Officer's Reply

For Council Reply Hearing:

Plan Change 7 to the Canterbury Land and Water Regional Plan; and

Plan Change 2 to the Waimakariri River Regional Plan

Figure 1. Recommended amendment to the IFSH map layer in Irishman Creek up and down stream of Tekapo Canal.

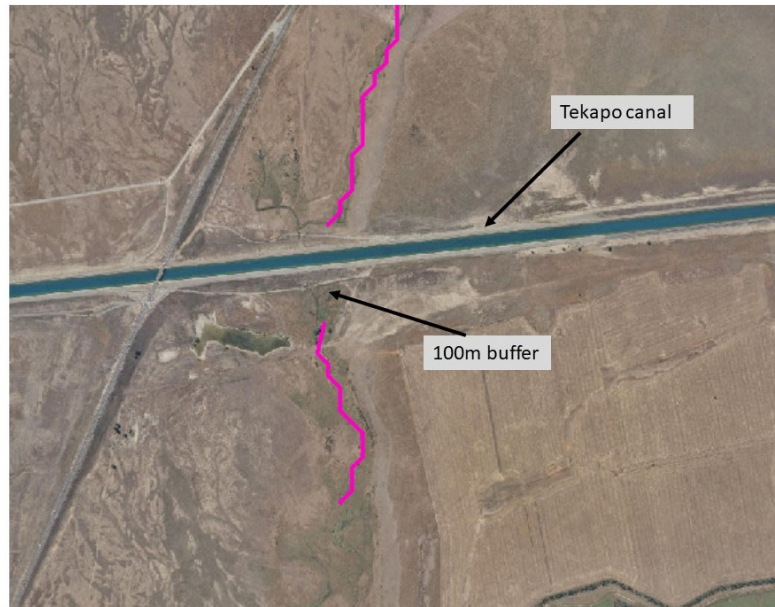
of the culvert to provide a permitted activity pathway for activities associated with this hydro-electricity generation structure (Figure 1).

Figure 2. Upper Coopers Creek “sub-catchment” water use.

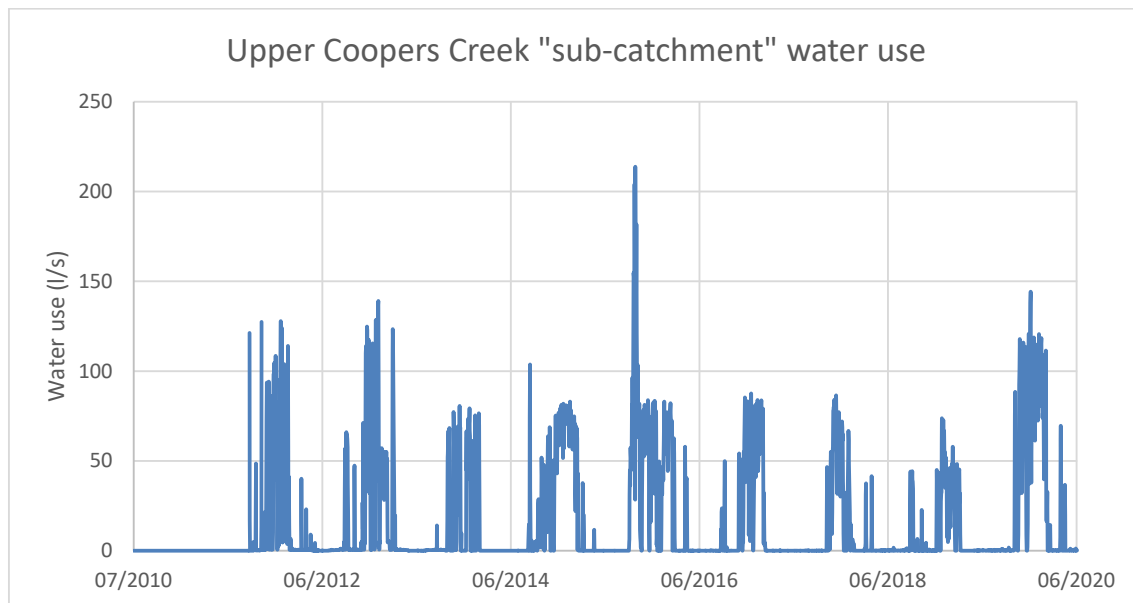
- 24.11. The sum of water authorised to be taken under the three submitters' consents is 234 l/s. The water usage data suggests that the submitters' usage is much less than their allocated maximum rates. This aligns with other metering data within Canterbury. The water usage reflects a combination of climatic demand, irrigation management and minimum flow restrictions at the time.

- 24.12. As water usage is consistently less the allocated amount, the consent holders may be able to increase their usage beyond what has occurred in the past. For this reason, Officers consider it is important that the flow regime is set at a level that ensures instream values are protected if consent allocations are fully used.
- 24.13. The effects of abstraction based on previous usage reported by Mr Hickey and Mr McIndoe are likely to underestimate the possible effects which can occur if consent holders utilise their existing consents in a different way.

Figure 3. Estimated uncertainty range for modelled nitrogen loss rates associated with environmental input data from dairy farms on light soils.

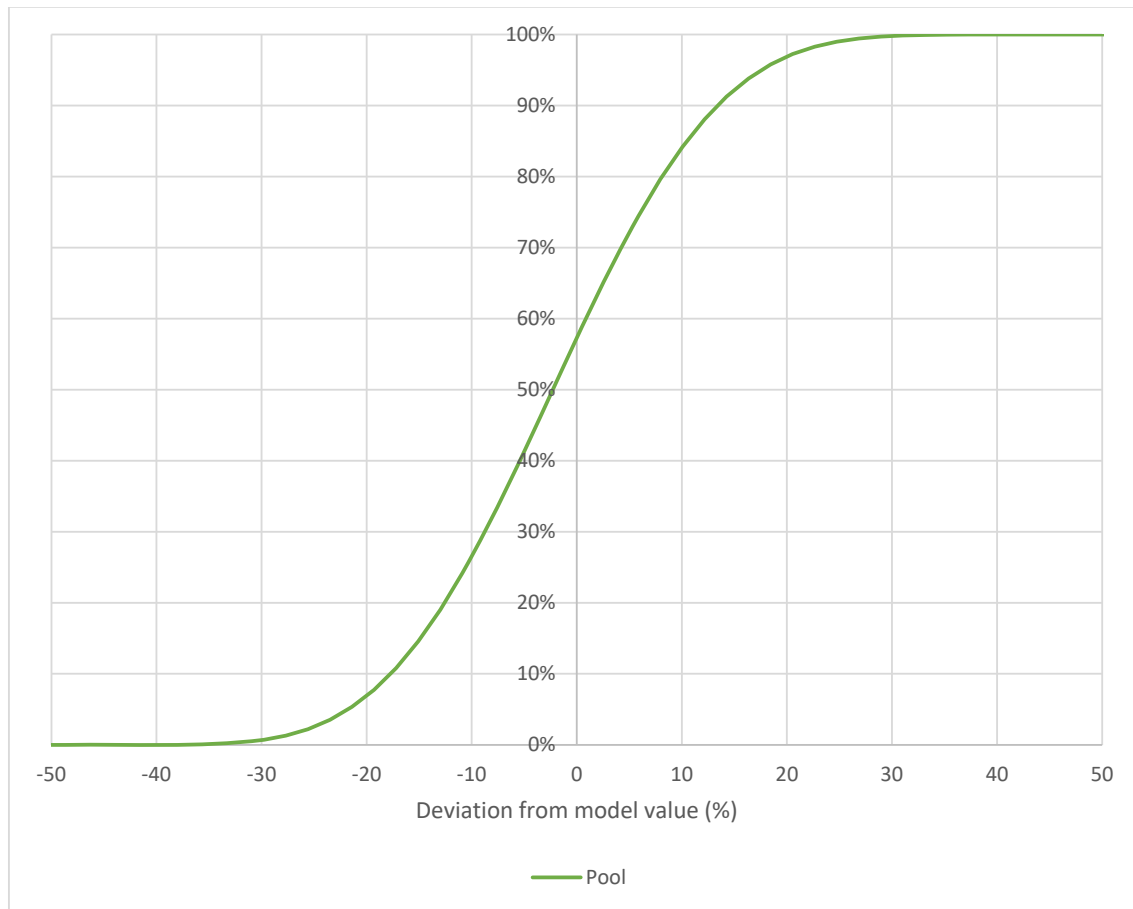
- 39.23. The estimated uncertainty range for dairy farms on light soils associated with environmental input values (i.e. soil type and climate zone) range from -20% to +20% for the 5th and 95th percentile values respectively as shown in Figure 3 below. The average 22% reduction in N loss calculated by Mr Hawkins associated with the soils data update therefore falls within the modelled uncertainty range and has therefore been accounted for, to some degree, as part of the broader evaluation of nitrogen modelling uncertainty. Furthermore, Mr Hawkins' presentation shows that dairy farming on Very Light soils represents 58% of the total mapped dairy farm area. The modelled N loss rate for dairy farming is 1,953 t/y for the Final ZIPA
